Subject: Description of Permissive Change

FCC ID: ZUA-AUTO-NACS01

Model Name: NACS01

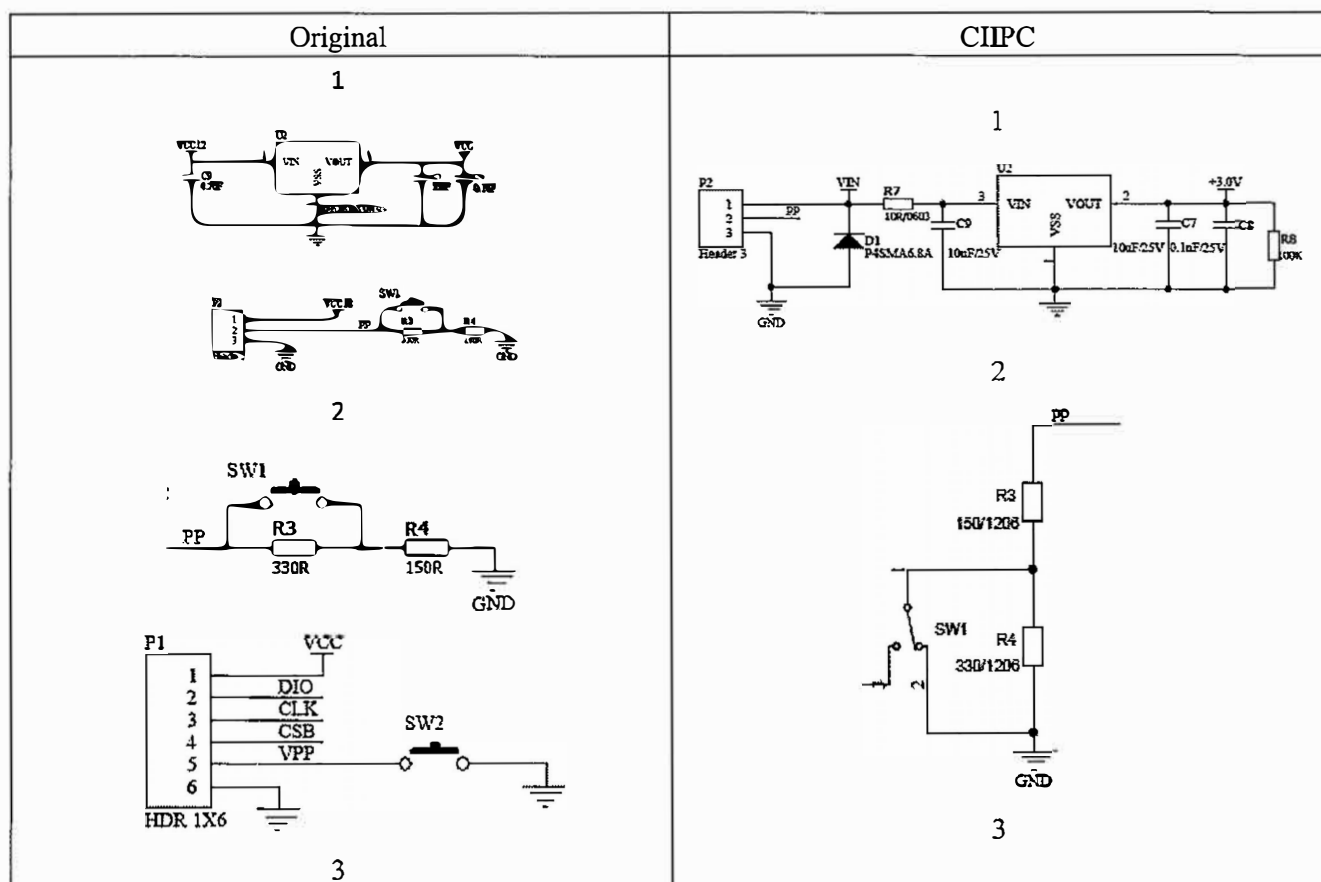
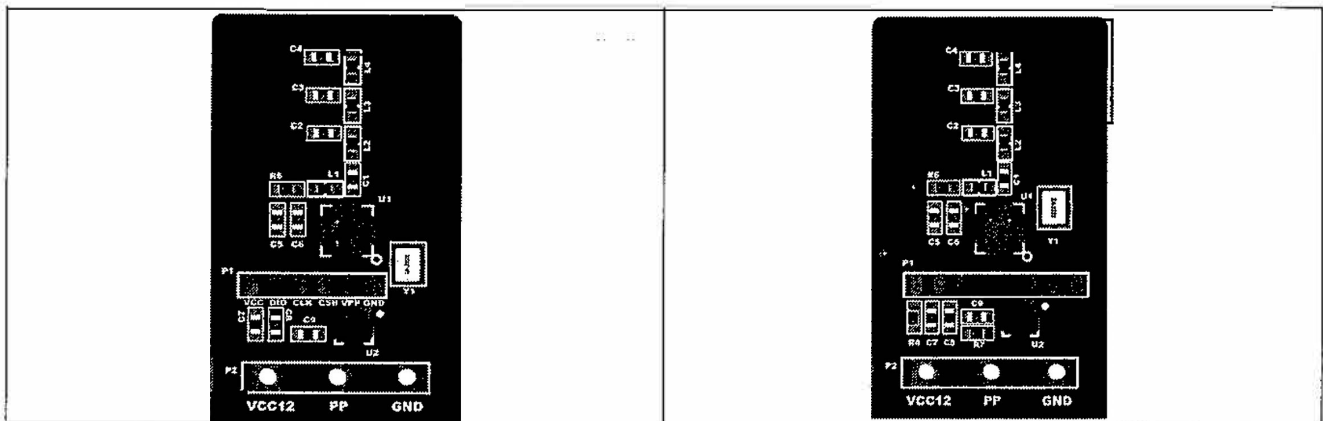
1. The power supply has been modified and some protective measures have been added, such as current limiting resistors R7, TVS tubes D1, and loads R8. It have two different version for D1, the VIN of EUT is different.

Version	D1 Model	VIN
Version 1	P4SMA6.8A	DC 3.3V
Version 2	P4SMA18A	DC 3-15V

2. The RF triggered button SW2 and the charging gun identification resistance switch button SW1 are integrated into the SPDT button.
3. Changed the antenna size.
